FIAT SERVICE LETTER

SUBJECT: ELECTRONIC IGNITION CONTROL MODULE

VEHICLES: 1979 X1/9 VEHICLES

NUMBERS MUST
BE THE SAME

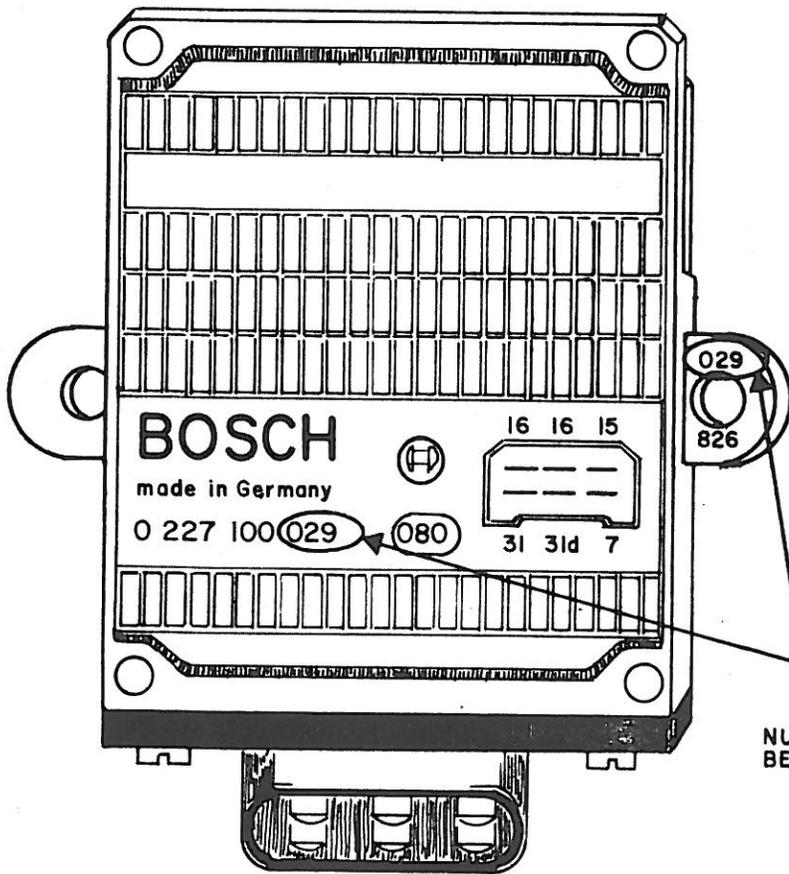
CONDITION: Tachometer does not operate.

CAUSE: Possible improper assembly of the ignition electronic control module.

CORRECTION: Inspect the electronic control module to insure the three digit number "029" located on the module face plate, is also stamped on the right side mounting ear of the module assembly. (See illustration.)

If the three digit number on the mounting ear is not "029", the control module must be replaced.

The part number for the electronic control module is #4419628.
